Docket No. 50-537
HQ:S:82:055

RESPONSES TO REQUEST FOR ADDITIONAL INFORMATION

Reference: Letter, P. S. Check to J. R. Longenecker, "CRBRP Request for Additional Information," dated April 30, 1982

Figure QCS 760.77-1. Friction Factor Data and Correlation for 217 Pin Wire Wrap Spaced Fuel Assembly

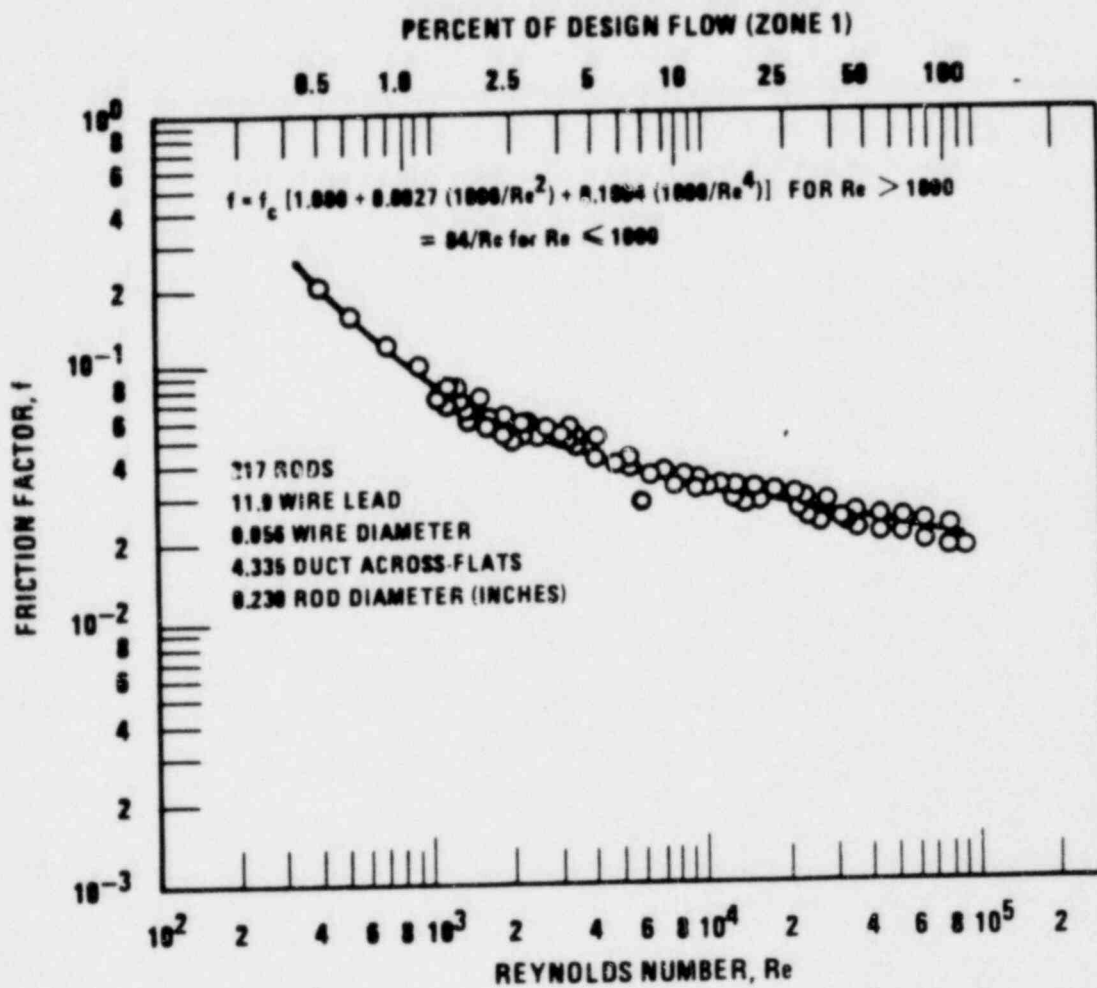
Section 4.4.2.7 of the CRBR PSAR presents a discussion of pressure drop calculations and experimental results at full flow conditions. Is there a similar analytical and experimental base for low flow conditions? If not, how are pressure drops for low flow conditions determined? If there is a similar data base for low flow conditions, please provide detailed information in the form of calculated and experimental pressure drop data including uncertainty factors?

Additional data and correlations such as those shown in Figures QCS760.77-2 and -3 for the blanket and control assembly rod bundle friction factors are under development. Also, a more recent fuel assembly friction factor correlation than the preliminary correlation shown in Figure QCS760.77-1 was developed based on 266 additional data points (Reference QCS760.77-1) but which differs from the Figure QCS760.77-1 correlation by only 0.2% at high flow rates and a maximum of ~2% in the transition region.
